FINAL
NAVAL AIR STATION ALAMEDA RESTORATION ADVISORY BOARD
MEETING SUMMARY

September 04, 2008

PROPOSED REMEDIAL DESIGN AND REMEDIAL ACTION SITE 1

AREA 1b - IMPLEMENTATION

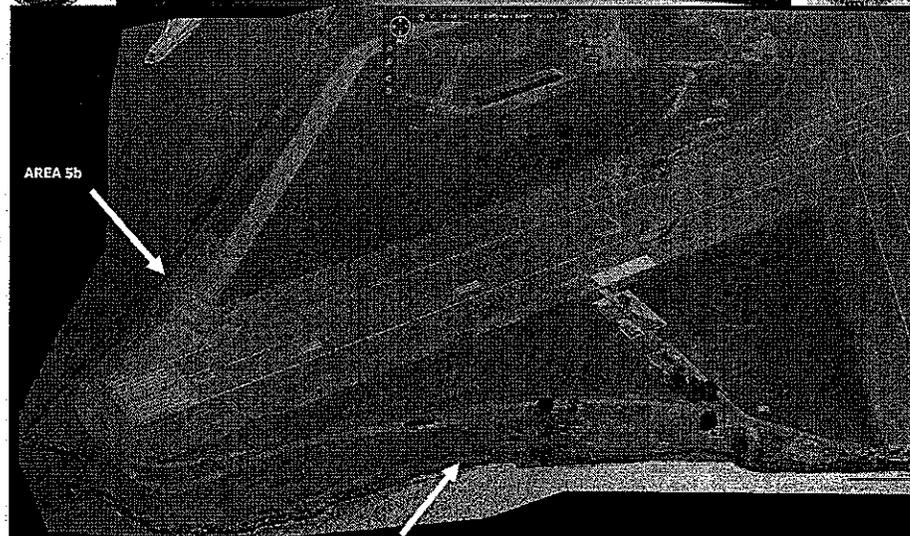
The remedial plan for Area 1b (burn area) is excavation, characterization of waste for proper disposal, and backfilling per the seismic design. During implementation (Slide 13), an in situ radiological (RAD) screening pad will be set up. Soil areas hot with RAD activity, identified by a drive-over scan, will be removed with an additional 1 foot of soil and transported to a secondary RAD screening. RAD items would be taken to the intermodal radioactive bin and RAD disposal area. Mr. Hoffman asked if anything other than RAD would be screened, and Mr. Robinson said that other chemical constituents will be evaluated. Mr. Hoffman asked if excavation would continue to the depth of the water table and whether water samples would be collected. Mr. Robinson said that the current proposed plan includes excavation to the water table, which is 3 to 7 feet below ground surface (bgs) at Site 1, but water samples would not be collected. Mr. Hoffman commented that it would be a good opportunity to collect water samples because the area is downgradient of the waste cells.

Mrs. Konrad asked what will be done with the excavated soil. Mr. Robinson said that the excavated soil will be characterized and, if hazardous, disposed of properly. If the soil is not hazardous (according to the current plan), the soil will be used for the initial grading at Area 1a, and eventually located under the 4-foot soil cover. Mrs. Konrad said that SunCal suggested developing a wetland in that area instead of a golf course. She noted concerns that work might be done that is not needed, depending on the plan. Mr. Brooks said that SunCal’s plans are in the conceptual stage and SunCal will need to coordinate with the Navy and regulators before any development occurs at the site. He said the first meeting with SunCal is planned for September 23, 2008. Mrs. Sweeney said that a wetland area would be appropriate near 1a landfill area, and the Navy should plan for it.

AREA 1a – DESIGN

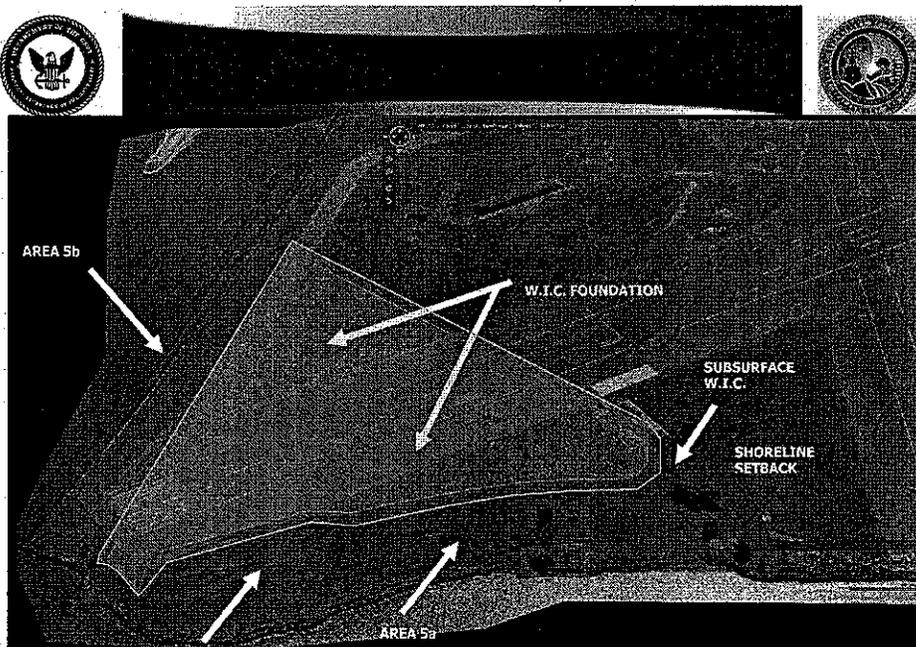
Mr. Humphreys asked the definition of WIC (Slide 18). Mr. Robinson said WIC is a waste isolation cover, or soil cover. Mr. Robinson said that soil gas samples will be collected to determine if methane was being produced. Mr. Humphreys said that the soil gas sampling should also include vinyl chloride.

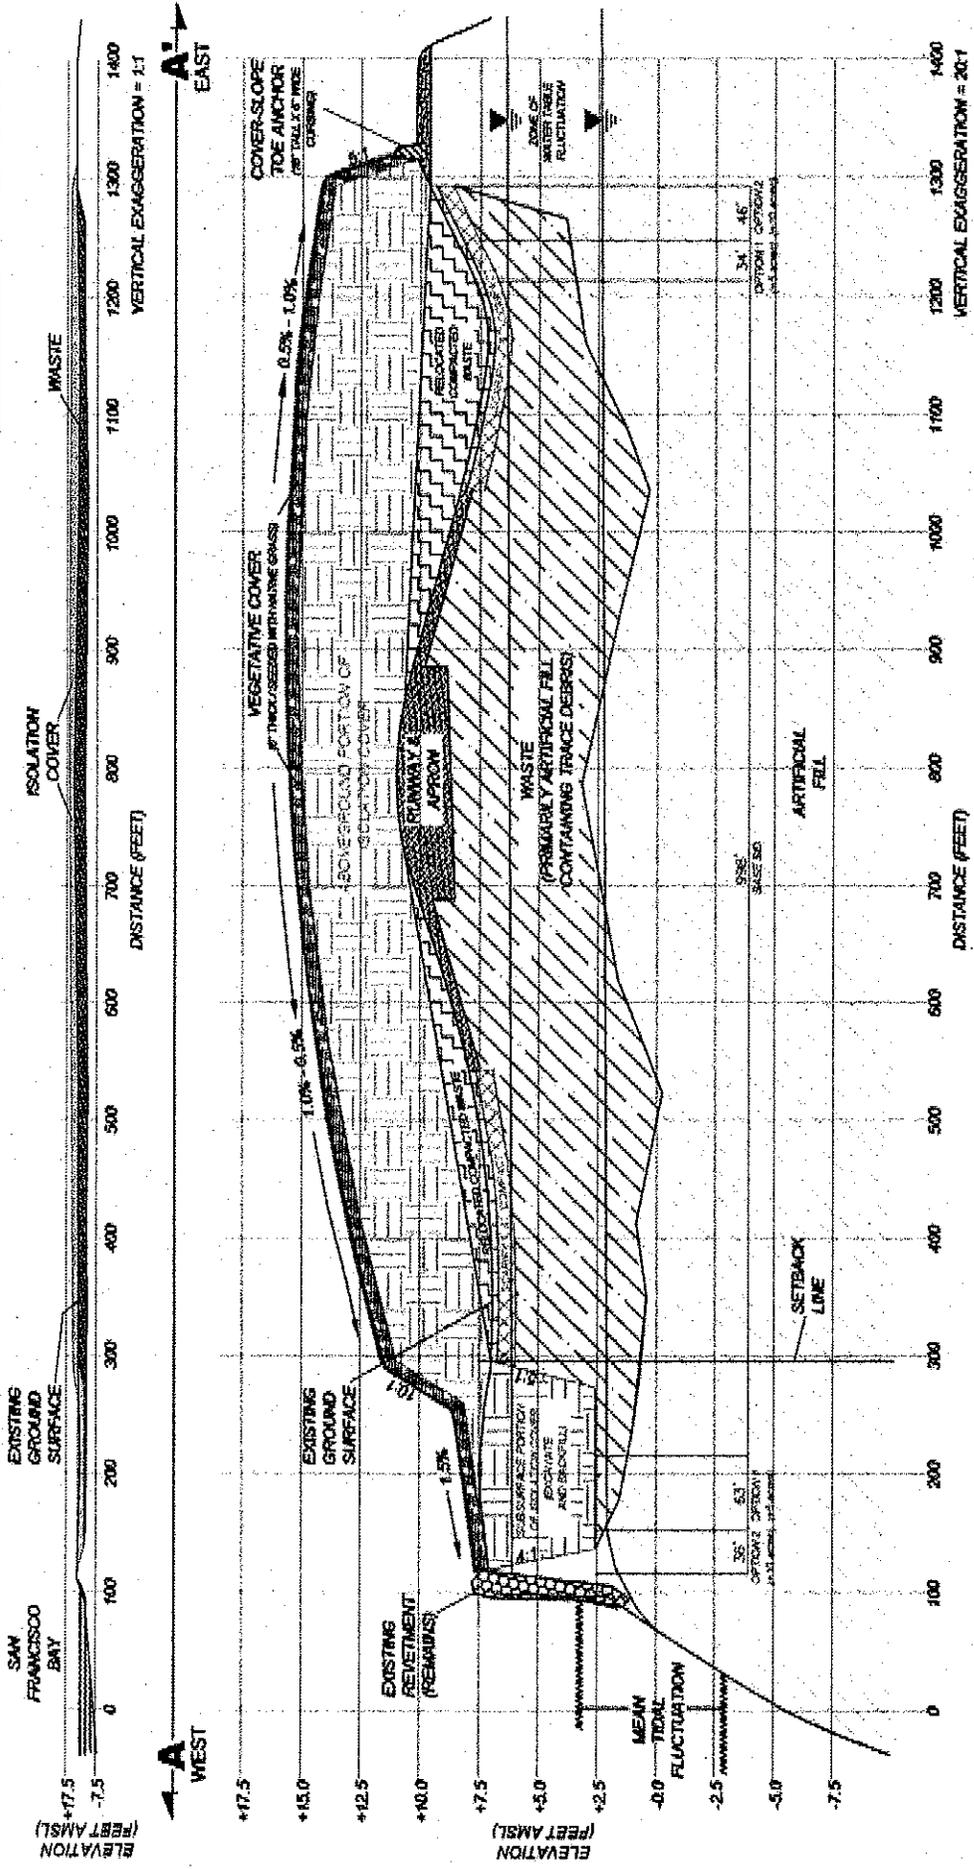
Mr. Robinson explained the overall construction progression for Area 1a (Slide 20). The Navy will start work with Area 1b excavation, and then address the beaches because both of those have potential for producing soil that can be used to fill in low spots for initial grading at Area 1a. For the shoreline, which is a seismic concern area, 4 feet of soil will be excavated 200 feet away from the shoreline. This area will then be backfilled and compacted to stabilize the shoreline. Ms. Smith asked if rip-rap will be added. Mr. Guerra replied that the existing rip-rap will be used. Mr. Robinson added that excavating to 4 feet may remove the soil that contributes to the plume. Mr. Hoffman suggested that the plume could be removed by excavating to the bottom of the waste. Mr. Robinson said that this option will be discussed with the contractors.
